26 March 2020
Project: (200062)

**RE: 224 ARDAGH ROAD (204 FERNDAL DRIVE S) PROPOSED MIXED-USE
DEVELOPMENT, BARRIE
ADDENDUM TO MAY 2018 TRAFFIC BRIEF**

Re: D11-021-2019 – 224 Ardagh Road

Figure 1 and **Figure 2** illustrate the updated 2020 and 2025 total traffic peak hour forecasts, respectively.

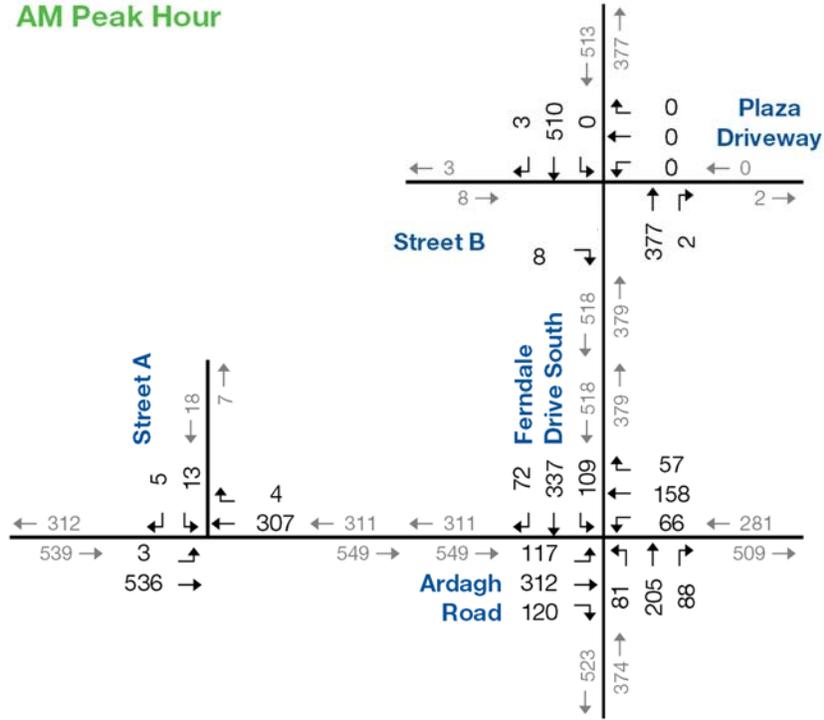
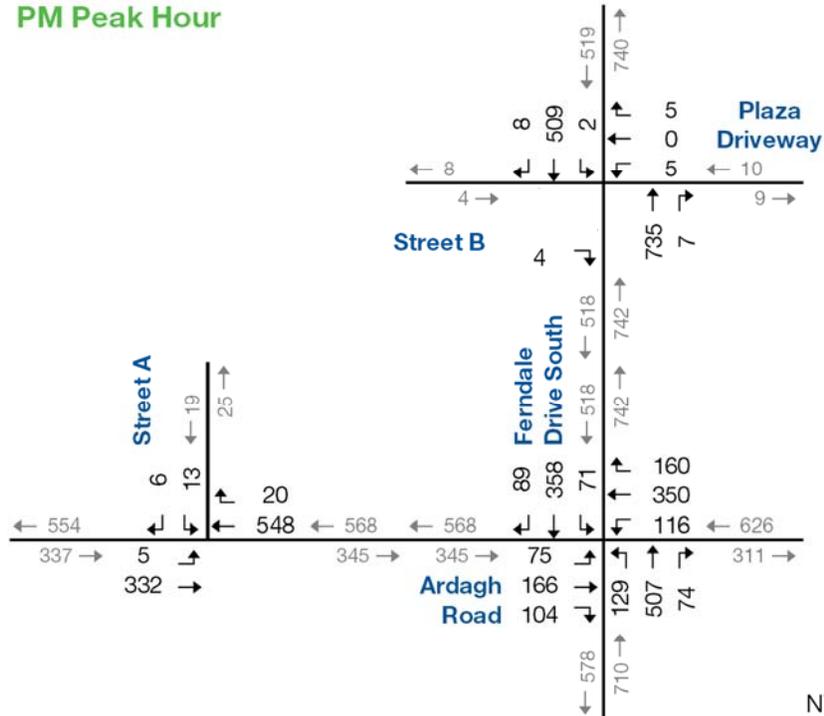
1. The submitted Traffic Impact Study shall be updated to reflect the access onto Ferndale Drive being restricted to right turn in/right turn out only.

2. Staff do not support a full move access onto Ferndale Drive, as the proposed access is within 70 m of the intersection of Ferndale Drive and Ardagh Road. Staff require this access be restricted to right turn in/right turn out only by implementation of a "pork chop" island.

The site trips generated by the development were reassigned to the adjacent roadway network based on existing traffic patterns and logical routing to/from the site location, reflecting the restricted access at onto Ferndale Drive.
